Product Change Notice for Ag5300

This communication is to inform you of an upcoming change to the Ag5300, 30W, IEEE802.3at Compliant, PD module and emphasises our commitment to provide world-class quality and support to our customers.

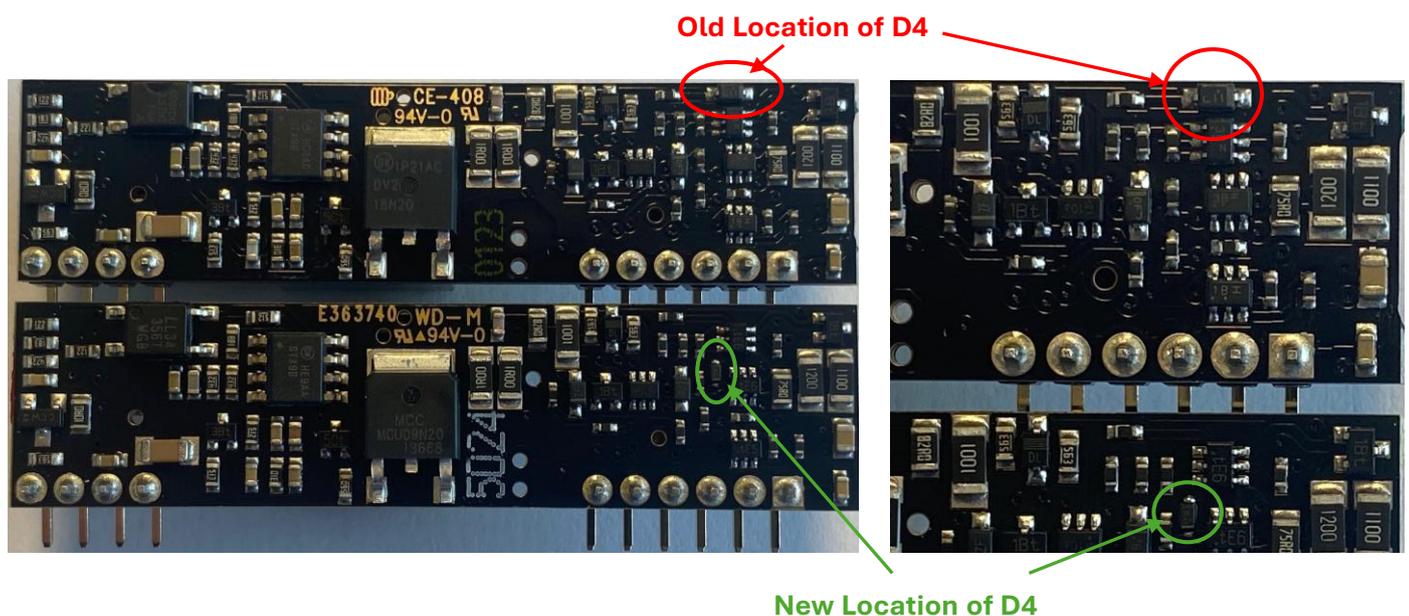
Hardware change only on a gradual phase-in.

To reduce susceptibility of handling damage to D4 Diode – part of a continuous improvement initiative.

The Ag5300 (12V) variant has undergone modification to improve the robustness of the module. In some cases, Diode D4 has been damaged and/or dislodged due to impacts resulting from manual handling. Silvertel has taken the opportunity to reduce the component package size and to relocate the component on the module, making it less prominent in profile and location, without affecting module performance in any way.

The impact of this change is “minor” having **NO AFFECT** to the FIT, FORM or FUNCTION of the module. The location of the diode has changed, and the diode itself will look visibly different. No power line tracking has been changed and only a single signal trace has been re-routed. Performance of the module is unaffected as is its EMC performance (pre-compliance test results available on request).
